UNITED STATES PATENT AND TRADEMARK OFFICE

Office Action Summary	Application No. 10/563,886	Applicant(s) KESKI-NISULA, KATRI	
	Examiner YOGESH PATEL	Art Unit 3732

DETAILED ACTION

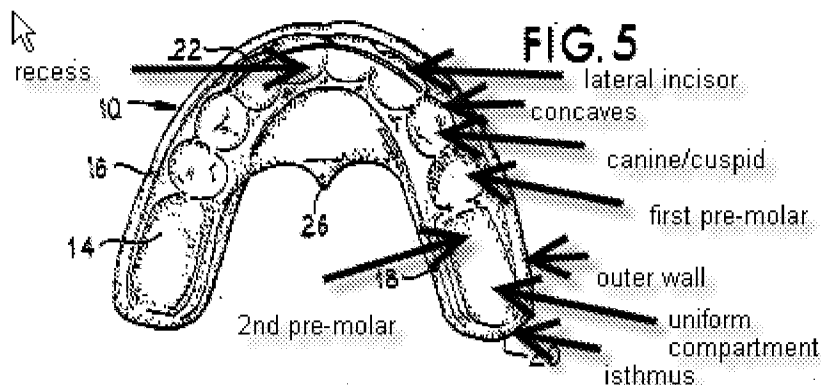
2. Claims 1-5, 18-23 are rejected under 35 U.S.C. 103(a) as being unpatentable over Bergersen (4,784,605) in view of Bergersen (4,830,612).

Bergersen '605 discloses a generally U-shaped arch (fig. 1) having a lower surface on the lower jaw side (fig. 5) including concaves for the teeth of the lower jaw, and an upper surface on the upper jaw side (fig. 1) including concaves for the teeth of the upper jaw, an isthmus 20 forming bottoms of the concaves and separating the upper and lower concaves, side walls of the concaves which are formed by outer walls on the labial or buccal side, respectively, and by inner walls on the lingual side, wherein the concaves comprise recesses arranged on the isthmus, at least part of the recesses being arranged for individual teeth, and wherein recesses for the back teeth consist of uniform compartments, which start from the second premolar and continue towards the

Bergersen'605 further discloses the compartment are shaped like continuous trough as seen in figure above, also individual blank for canine teeth as shown in figure above and the size of the appliance (col. 2, lines 38-41), but not specifically as claimed. However, the dental structure of users (e.g. dentition) varies in sizes depending on particular users' age. For example, if the user is 15 years old, then the length of the compartment would be lesser than the compartment length for user that is older than specified age and vise versa. Therefore, it would have been obvious to a person of ordinary skill in the art at the time of the invention was made to have provided the
